TECHNICAL SERVICE BULLETIN - Passenger

ARTICLE **1/98**

TITLE - **DOOR LOCKS CYCLING / OPERATING INCORRECTLY**

MODELS - EF/EL Falcon, NF/NL Fairmont and DF/DL LTD

Actuator Latch Distance Check (Front doors only)

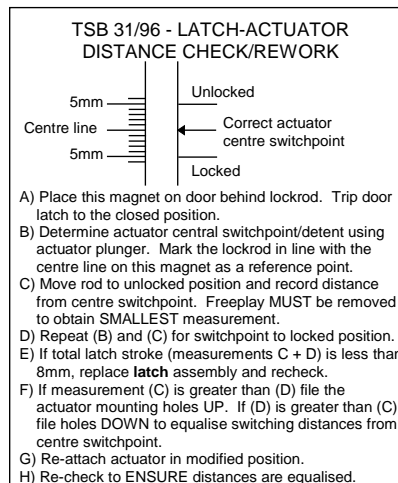
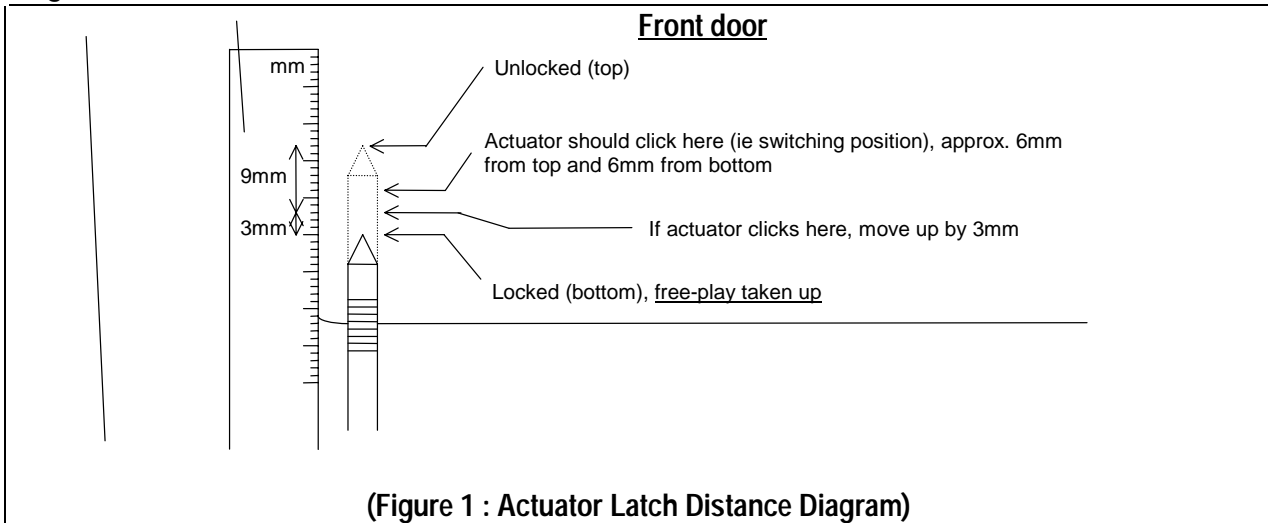
***Both front doors should be checked unless the vehicle has been fitted with only a driver's side snibber button in production. In this situation it is only necessary to check the driver's side front door. When assessing a vehicle for door lock cycling (due to a latch actuator distance error) measure both the stroke of the door lock assembly and the position of the actuator switching with relation to the stroke.***

- f) Using the fridge magnet or ruler beside the button rod, measure the distance from this switching point to the bottom (locked) position (Figure 1).

- h) If the total latch stroke (locked plus unlocked measurements) is less than **8mm** and has excessive free-play (greater than 3mm in both the locked and unlocked positions), replace the door latch. If latch is stiff in operation, lubricate or replace latch as necessary.

- i) The switch point to locked and unlocked distances must be equal, and both must be greater than **4mm**. If the distances are outside these tolerances it will be necessary to perform the rework as detailed on page 6 of this TSB.

Latch deformation rework (Left front doors only, build date prior June 1st, 1996)

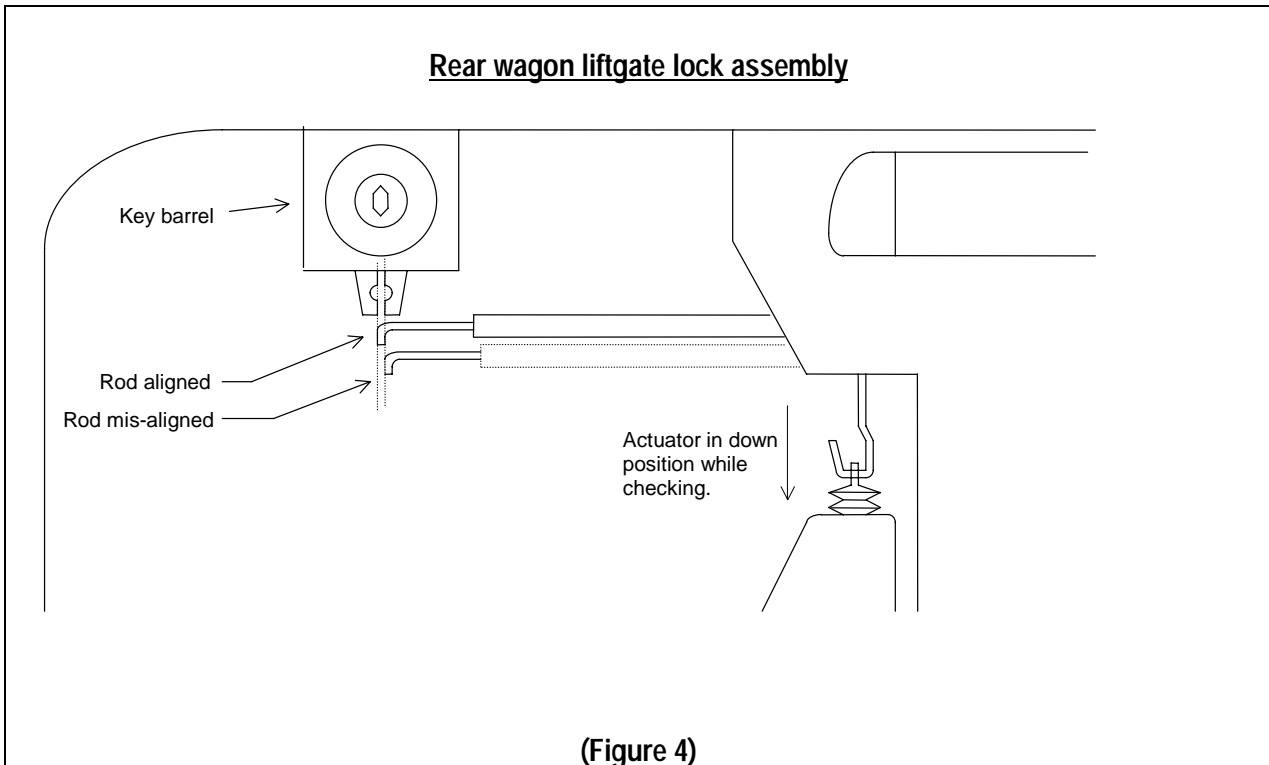
The door latch may deform due to the window runner rubber stopper applying pressure to the latch backplate, refer to Figure 3a.

- a) Obtain access to window runner mounting bracket.
- b) Remove window runner mounting bracket bolt.
- c) Widen the hole, with either a file or drill, by 2mm in a forward direction as shown in Figure 3b.

- d) Re-install the mounting bolt making sure that the bolt is as far forward as possible.
- e) If the LHF rod is restricted in movement when attempting to lock, then the latch assembly should be replaced.
- f) Ensure window operation has not been compromised and operates correctly.
- g) Do not replace all door covers and trim before reading the Actuator Test procedure on Page 9 of this TSB.
